LINCOLN & DRANSFELDT

WATER AND SANITARY PLANS

ISSUE DATE: 08-16-2021	PROJECT #: 200829
DATE	REVISION COMMENTS
11-17-2021	PER PWSD COMMENTS

PLAZA STREET PARTNERS

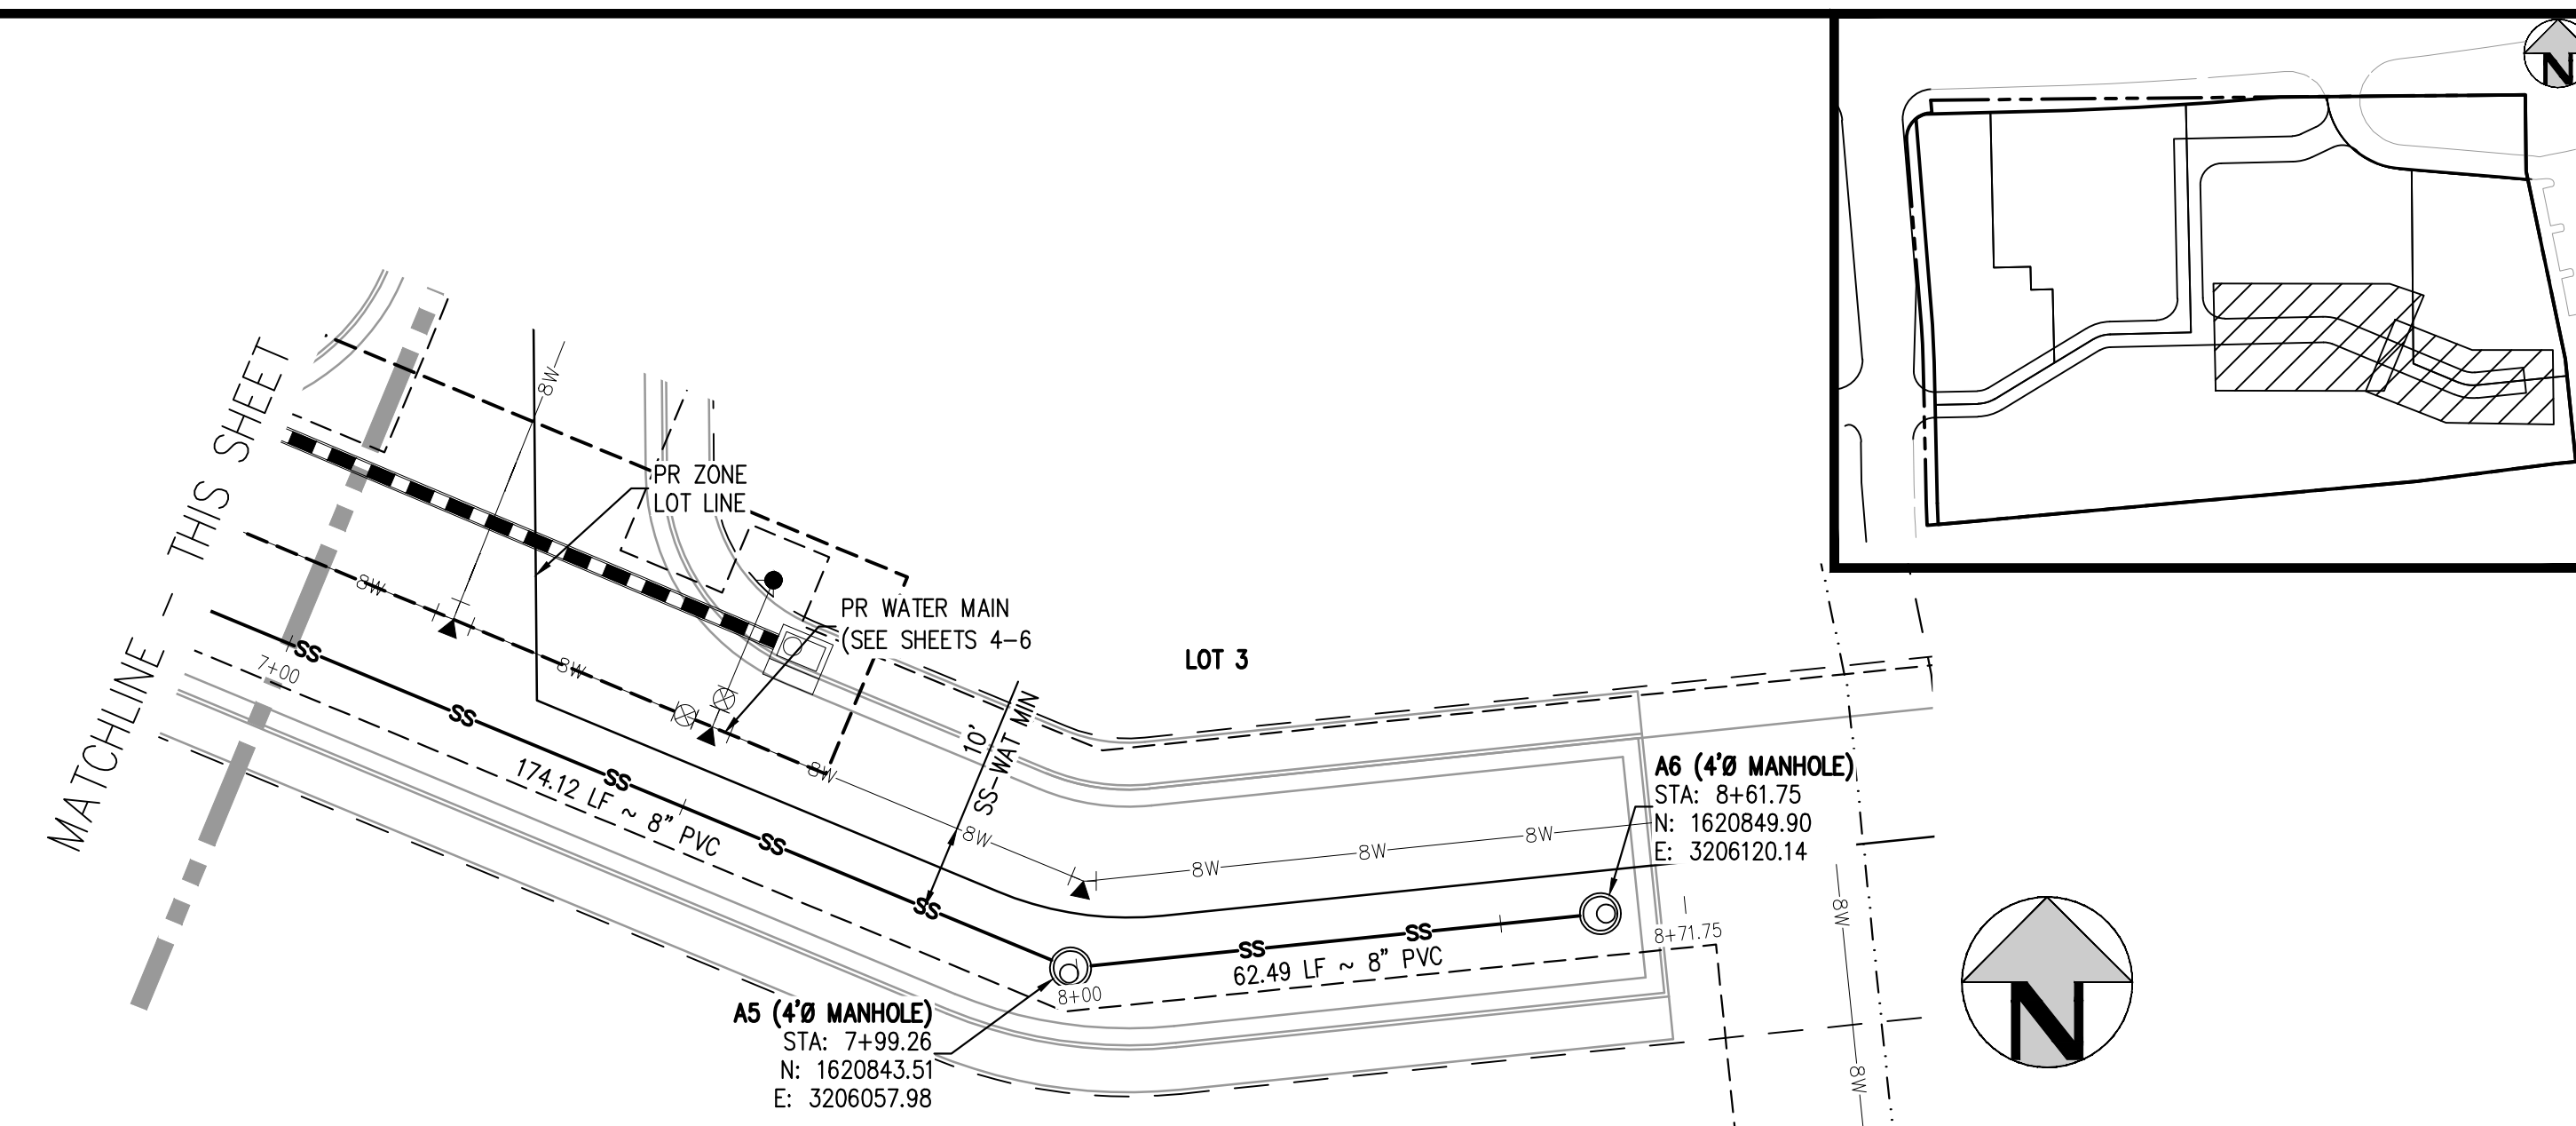
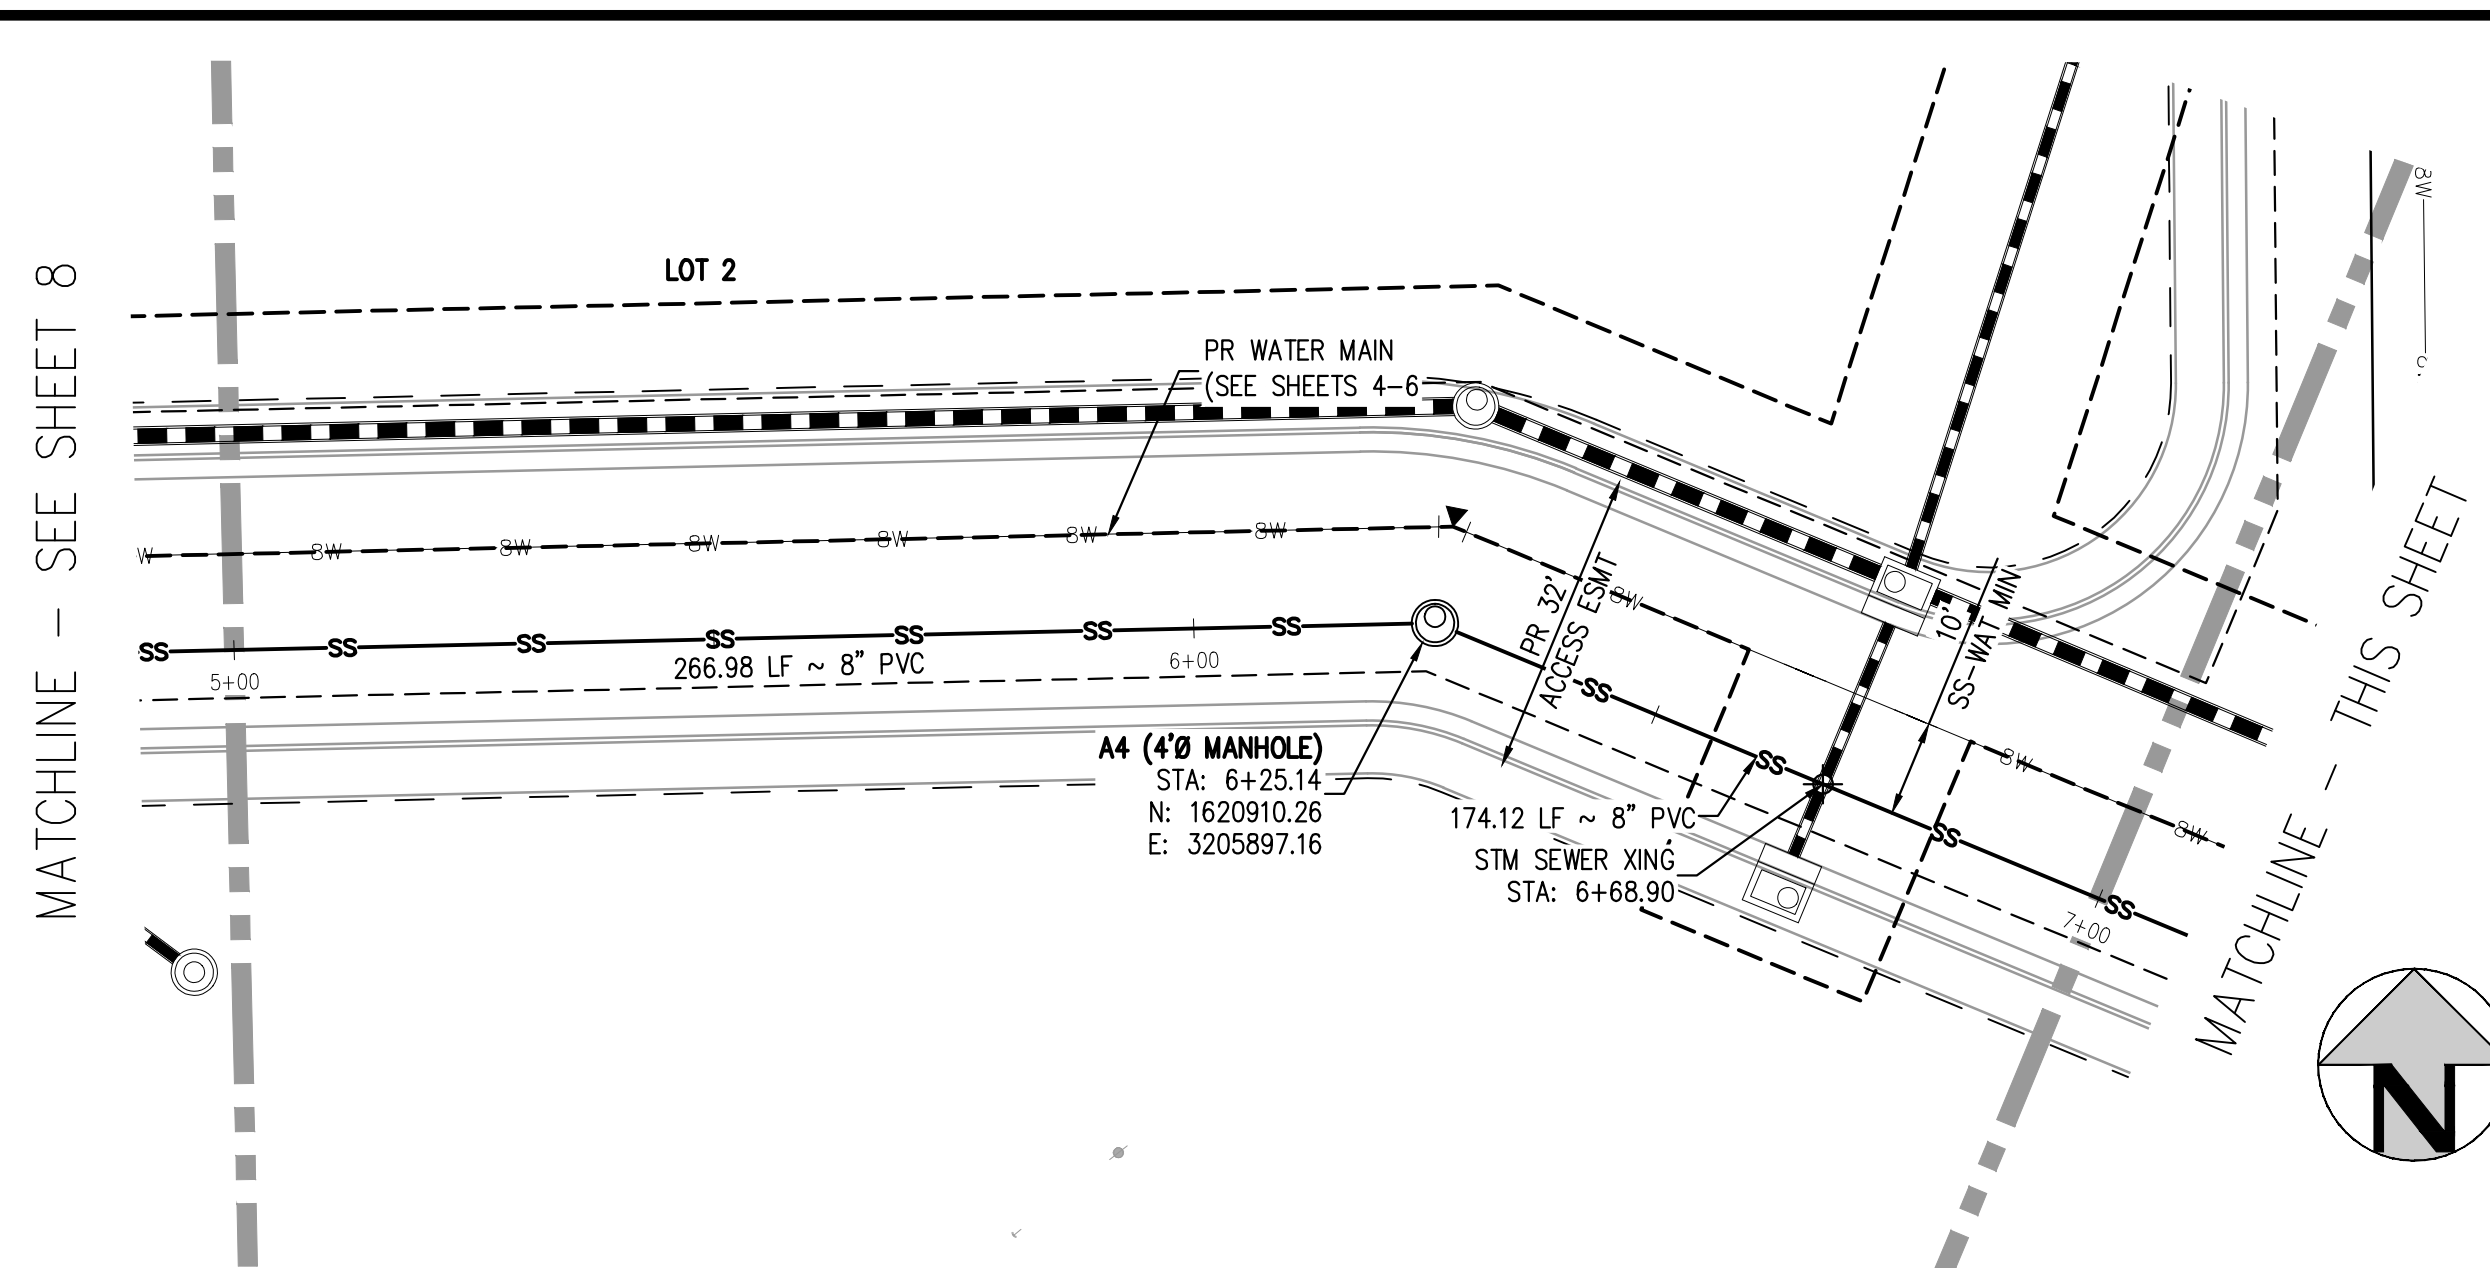
Add all relevant PWSD details after this sheet
Addressed
